## PERMIT

Permit Number: 091240

This is to certify that GRIBIZIS WILLIAM/TBD  
has permission to install a backup diesel generator w/ a 5' x 8' pad  
AT <sup>517</sup> ~~508~~ PRESUMPCOT ST CL 415 B006001

PROJECT NAME: VSEC Generator Placement
PROJECT ADDRESS: 522 Presumpscot Rd. Portland, ME 04103 (503 Presumpscot)
PROJECT DESCRIPTION: (Please Attach Sketch/Plan of Proposal/Development)
VSEC Request to install a Diesel Generator + 2' x 8' concrete foundation pad.

FIGURE 1: dBA TO FEET RATIO DIAGRAM  
TELECOMMUNICATIONS FACILITY  
PRESUMPCOT STREET  
PORTLAND, MAINE

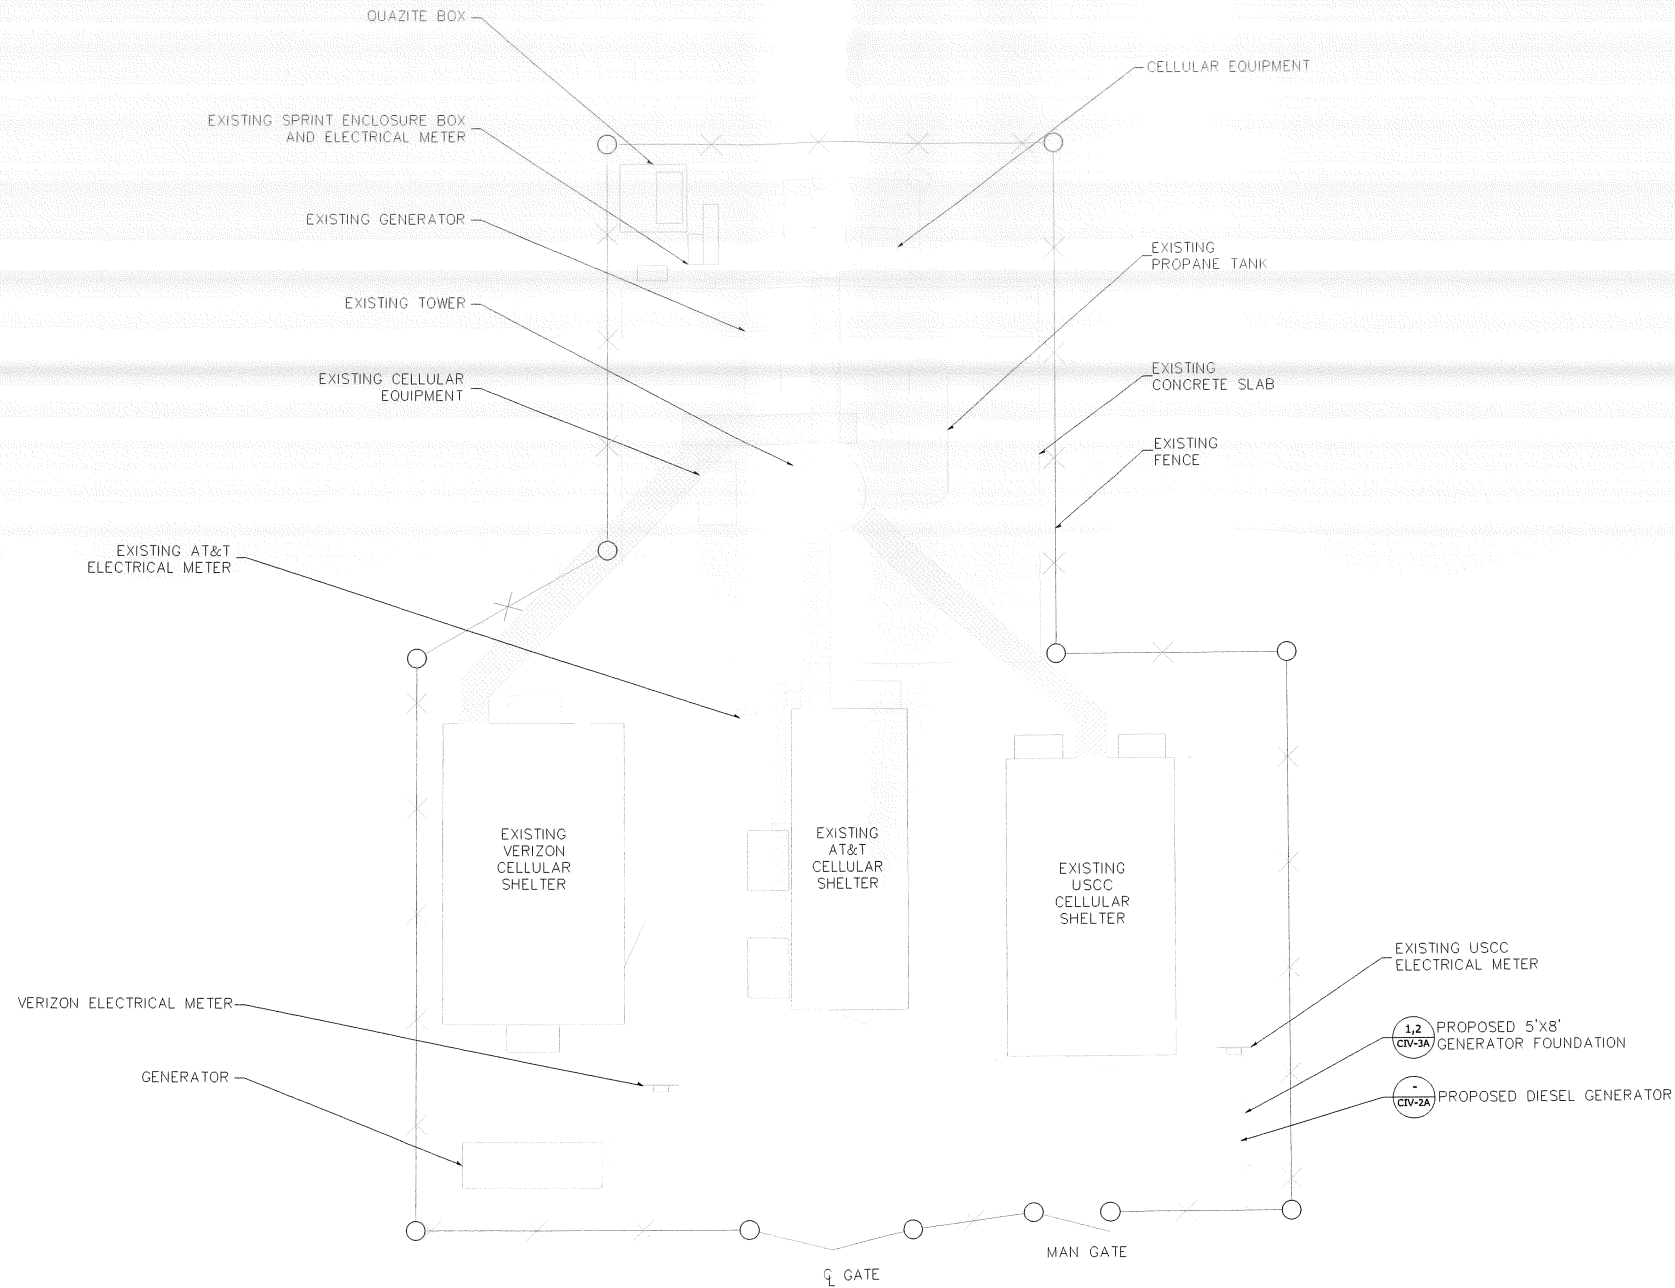
<b>Dept:</b> Zoning	<b>Status:</b> Approved with Conditions	<b>Reviewer:</b> Ann Machado	<b>Approval Date:</b> 12/01/2009
<b>Note:</b> Section 14-252(a)(3) states the maximum permissible sound levels at 70 dBA between 7 AM & 10 PM and 55 dBA between 10 PM and 7 AM. Information shows at 23' it is 68 dBA and at the property line (64') the dBA is 51.32.
